RE: Camas Woods Development (SUB24-1002) Completeness Review Response

This letter is written as a response to the Completeness Review Letter issued December 11, 2024. Each item from the completeness letter will be listed below in italics, with a response following the item.

L-11.3

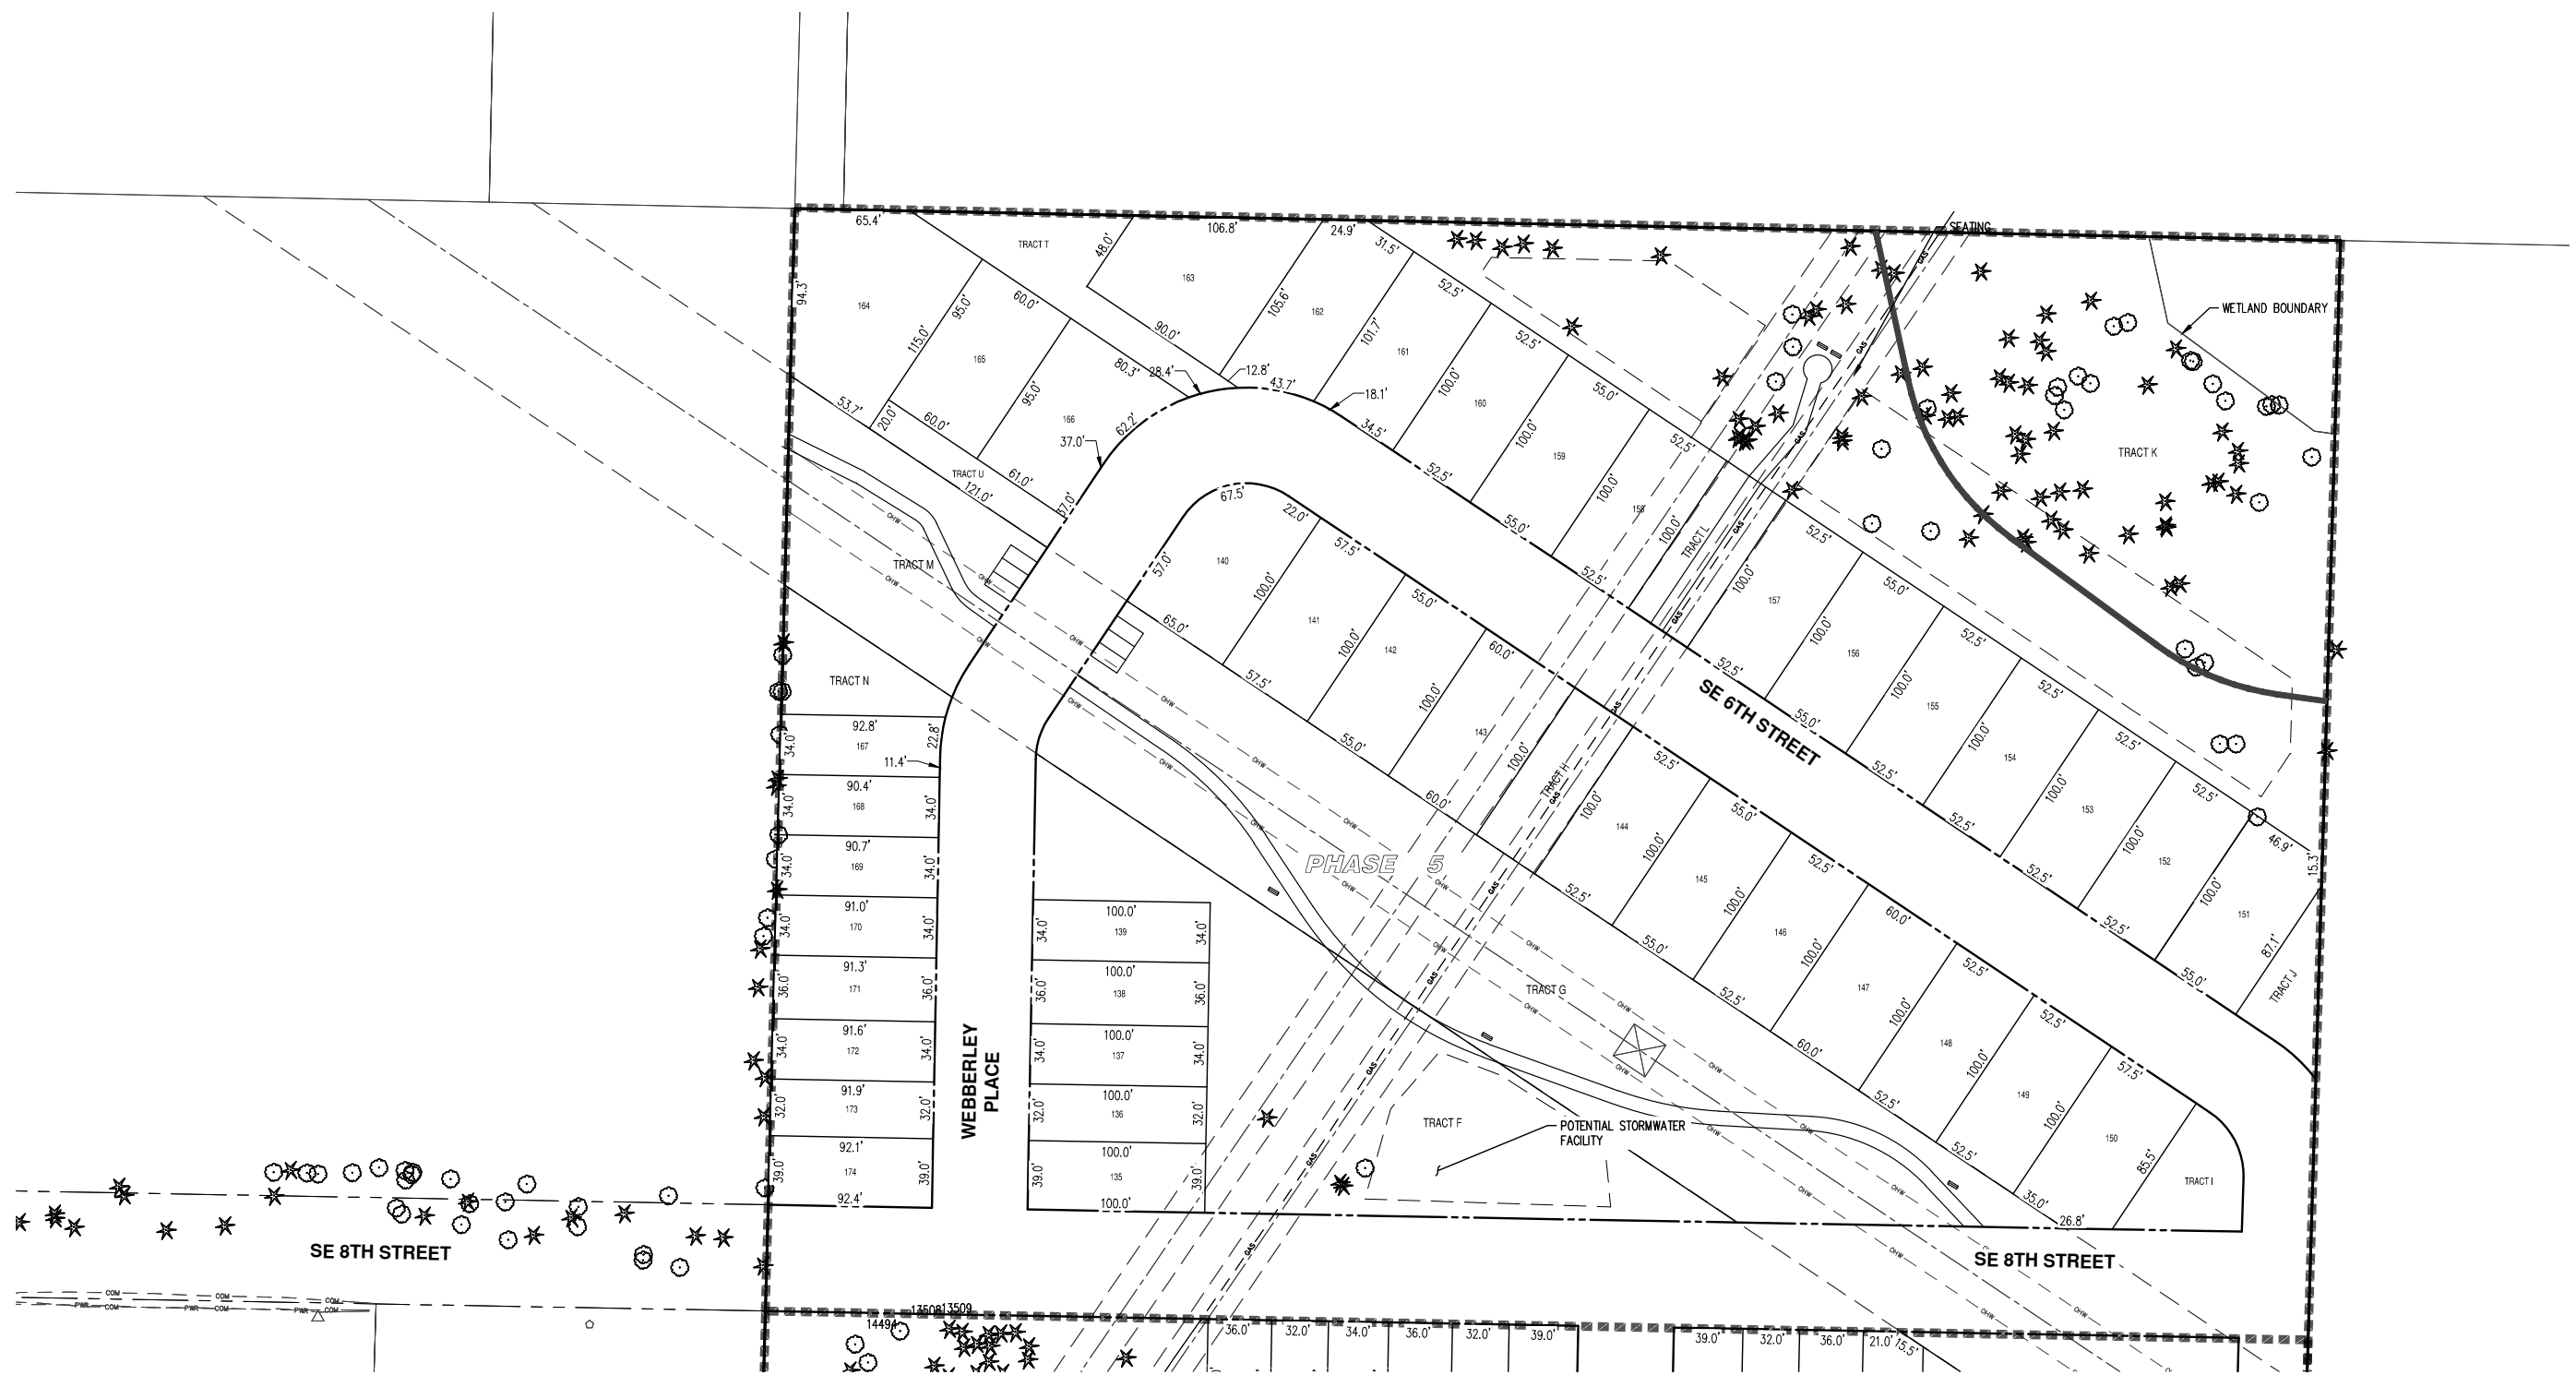
From: [Curleigh \(Jim\) Carothers](#)
To: andreottim@aks-eng.com
Cc: [Anita Ashton](#); [Randy Miller](#); [Robert Maul](#); [Madeline Sutherland](#)
Subject: RE: Camas Woods - Turnarounds on 150"+ Streets (Road A, Tracts P and S)
Date: Thursday, February 1, 2024 2:12:47 PM
Attachments: [image002.png](#)
[image003.png](#)
[image004.png](#)
[image005.png](#)
[8397_20240112_Camas_Woods_Updated_Plans.pdf](#)

Based on conversation in the Tuesday virtual meeting regarding your request to eliminate turnarounds for Road A, Tract P and Tract S, please find attached the response from the Fire Marshal's Office.

Curleigh, this is in response to our discussion about the Camas Woods project and their request for a compromise on turnarounds. When the distances, as in this case, are minimally longer than 150 feet the FMO has offered mitigation options that include additions to the life safety fire sprinkler systems already being installed. These additions include adding fire sprinkler coverage in areas not normally required in 13D.... All bathrooms, All closets, All garages and any other space not normally required by 13D, (excluding attics and crawl spaces unless gas fired appliance coverage dictates otherwise). These mitigation options help reduce the occurrence of significant fires requiring fire ground operations and the use of significant amounts of equipment and personnel.

There is not an easy way to track the above potential mitigation options into the future therefore approved plat notes will be required.

This compromise also seeks more spacious width access drives to provide effective police, fire, medical services to the homes at the end of these access drives.
